UNITED STATES
DEPARTMENT OF THE INTERIOR
BUREAU OF LAND MANAGEMENT

FORM APPROVED
OMB NO. 1004-0137
Expires: January 31, 2018**SUNDRY NOTICES AND REPORTS ON WELLS**
*Do not use this form for proposals to drill or to re-enter an abandoned well. Use form 3160-3 (APD) for such proposals.*5. Lease Serial No.
NMLC065347

☐ Oil Well ☒ Gas Well ☐ Other8. Well Name and No.
EDDY 21 FED COM 1

Permanent Abandonment of Federal Wells
Conditions of Approval

Eddy 21 Federal Com #1

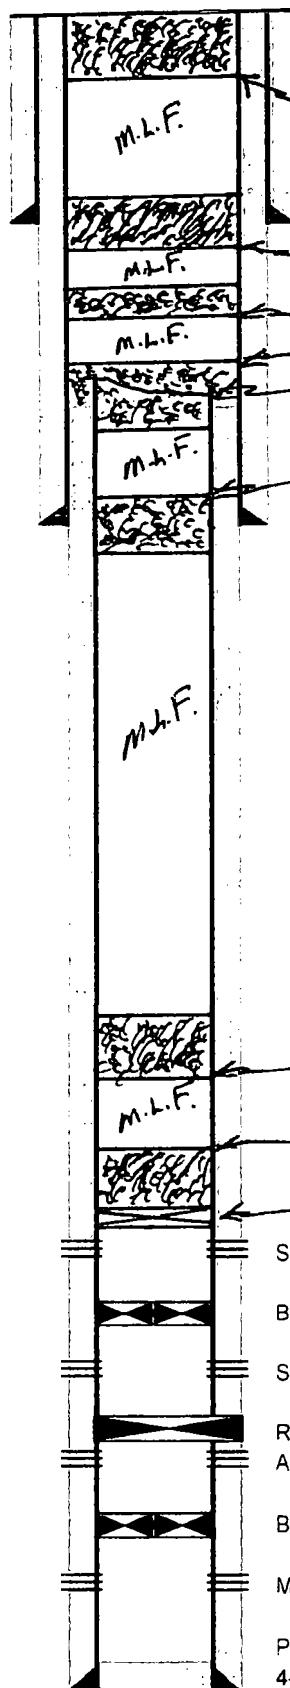
SEE ATTACHED FOR
CONDITIONS OF APPROVALspot plug from 1398-1298. B/sa.
WOC Tag.
T/salt. High Cave / Karst.GC 2/13/19
Accepted for record - NMOCD
